Technical Section 2a Webinar

Emulsified Asphalts

March 18, 2014

C. T 59 Emulsified Asphalts

Figure 1—Crow Receivers of 25-mL (0.8-oz), 50-mL (1.7-oz), and 100-mL (3.4-oz) Capacity

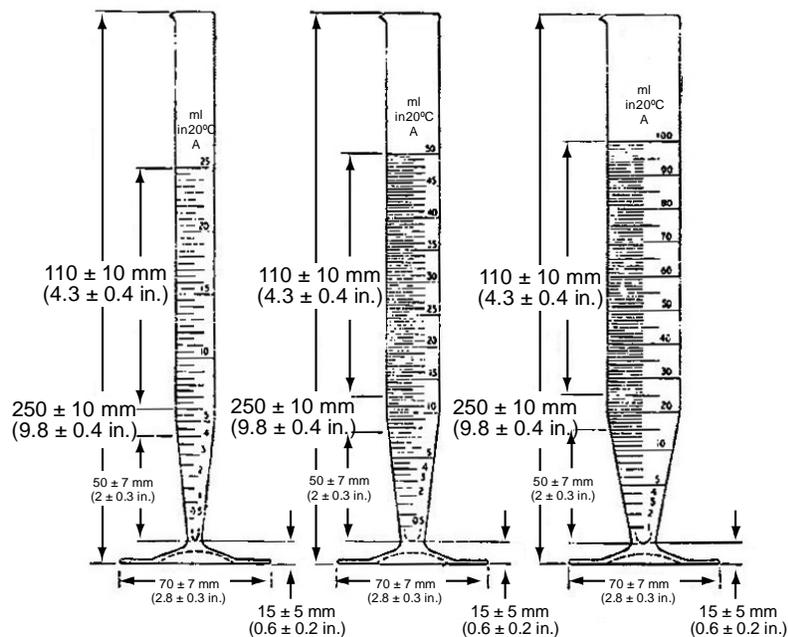
- - For this test method, the crow receivers are still in the standard. Are states using these or are just using a graduated cylinder? NJ is using a graduated cylinder. There weren't any states on the call that use crow receivers. Both the graduated cylinders and crow receivers will be included in the standard.

Figure 4 currently shows only Crow Receivers with numerous measurements including tolerances. Since the reference to the British standard is no longer listed should this figure should be replaced with a graduated cylinder or remove the measurements and tolerances and leave, but also include a diagram of allowed cylinders?
